**MINNESOTA POLLUTION CONTROL AGENCY
 RESPONSE TO COMMENTS ON ITS REPORT ENTITLED
 COMPARISON OF NITROGEN OXIDES, SULFUR DIOXIDE, PARTICULATE MATTER,
 MERCURY AND CARBON DIOXIDE EMISSIONS FOR IGCC AND OTHER ELECTRICITY
 GENERATION.**

Figure 3. Nitrogen Oxides, Sulfur Dioxide and Particulate Matter emission rates per MWh_{net} as a percentage of Excelsior (Mesaba) Energy I

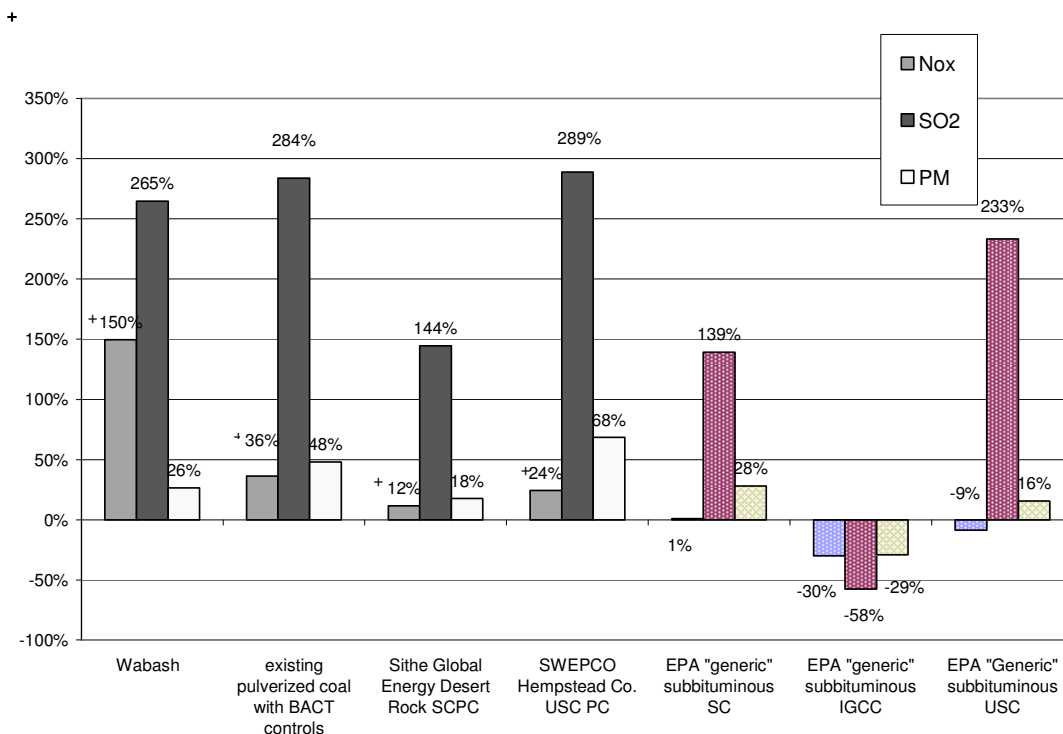
Comment: US EPA’s published comparisons were made on the basis of pollutant mass emitted per gross megawatt-hour (lb/MWH_{gross}). Ms. Jackson’s comparison between the project and other units are made on the basis of pollutant mass emitted per net megawatt-hour (lb/MWH_{net}).

Comment: The MPCA should use, analyze and compare emissions on a gross generating basis.

MPCA response: Mr. Evans is correct that EPA emission factors for generic subbituminous IGCC, supercritical and ultra-supercritical coal fired electric generating units are reported on a gross megawatt generated basis, not net basis as the MPCA intends the comparison to be made. MPCA converted the emission factors for these three types of units to a net generation basis, and they are noted in the revised table “Facility Emission Rates for Comparison”. The EPA emission factor for both gross and net generation for IGCC, supercritical and ultra-supercritical boilers are now shown in the table. Because of the change to the emission rates, Figure 3, the comparison of each facility to Mesaba Energy as a percentage of emissions from Mesaba Energy must be adjusted. Figure 3 is shown below; the corrected emission rates have been re-colored in order to indicate which part of the figure has been changed.

Therefore, the only adjustments the MPCA is making to its comparison of facility emission rates based on Mr. Evans' remarks is to change the emissions rate for the generic facilities' emission rates as described in the MPCA's response to the first comment. Figure 3 reflects this change.

Figure 4. Mercury emissions as a percentage of mercury emissions per MWh from Mesaba Energy I.

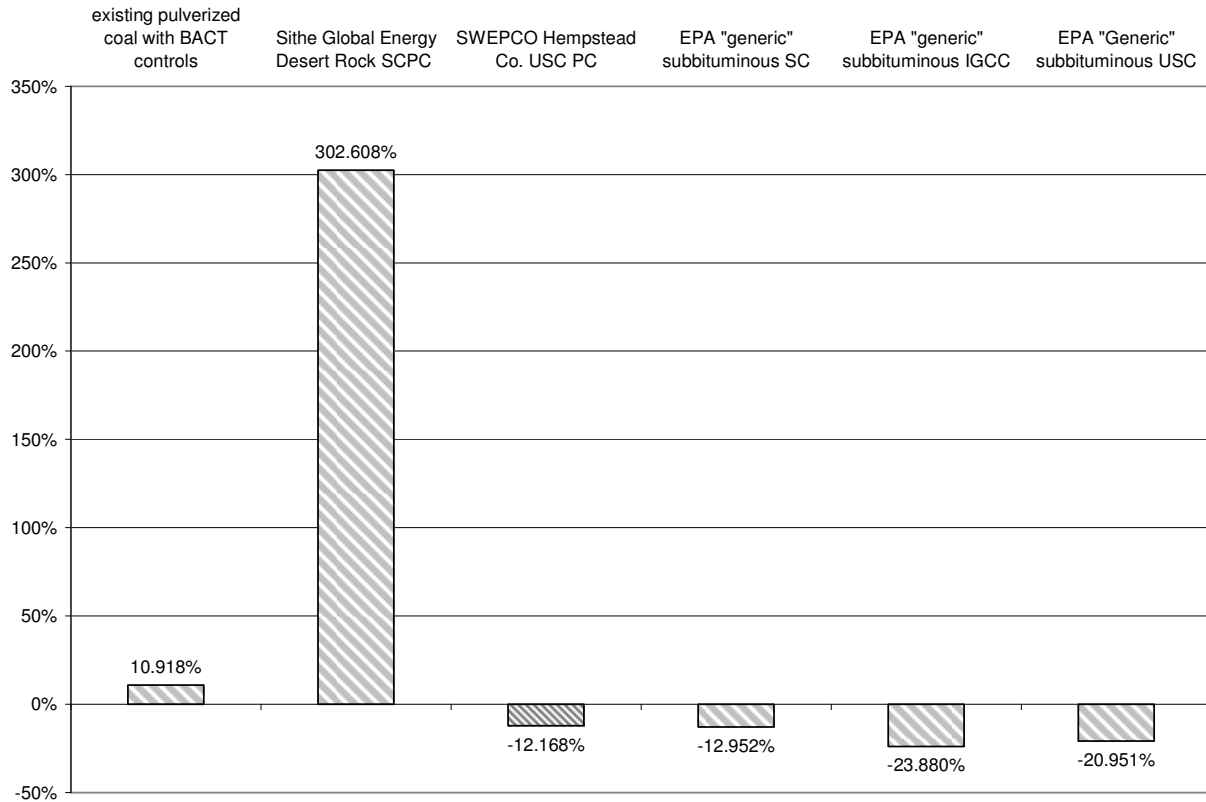
Comment: The mercury emissions rate for the SWEPCO Hempstead County proposal should be revised to reflect the proposed emissions rate in its permit application.

Response: The MPCA declines to change the mercury emissions rate for the SWEPCO facility for mercury, other than to correct it from a gross generation basis to a net generation basis. The SWEPCO Hempstead County permit application provided to the MPCA by the Arkansas Department of Environmental Quality identifies the new source performance standard adopted in June 2006 by EPA as the applicable permit limit for the proposed plant.

The MPCA believes it is highly unlikely that the SWEPCO facility will operate without mercury control of some form, either the control inherent to the proposed SO₂/PM/NO_x control, or the addition of powered activated carbon. As a result, the MPCA used the mercury emissions rate provided by EPA in the “Environmental Footprints and Costs of Coal-Based Gasification Combined-Cycle and Pulverized Coal Technologies” to represent mercury emission rates from a controlled unit. However, because the EPA emission rates are gross generation based, the MPCA adjusted the mercury emissions rate for SWEPCO Hempstead County to net generation base. Revised Figure 4 is provided below.

Figure 5. Carbon Dioxide Emissions per MWh as a percent of Mesaba Energy I

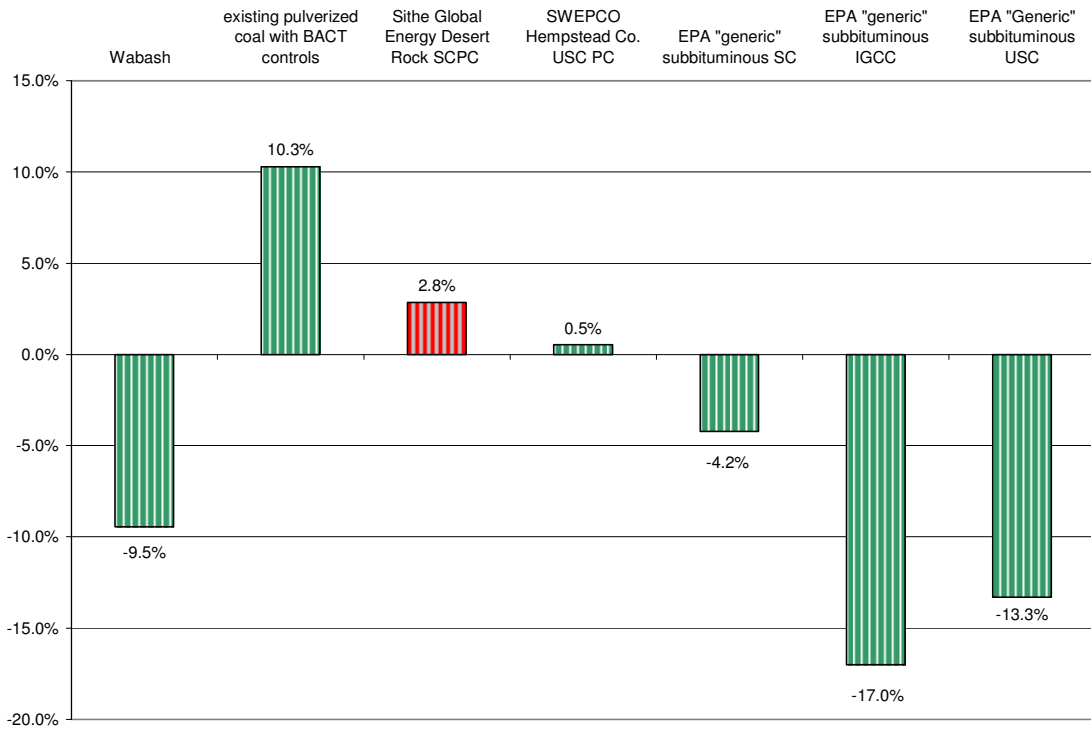
Comment: Sithe Global Energy Desert Rock CO₂ emissions look inappropriately low.

Response: The Sithe Global Energy Desert Rock CO₂ emissions were too low. The MPCA changed the CO₂ emissions rate to reflect the use of subbituminous coal in New Mexico. The values in the accompanying table have been adjusted, and Figure 5 is corrected as well. The change in the figure is recolored in order to shown where the change has been made.
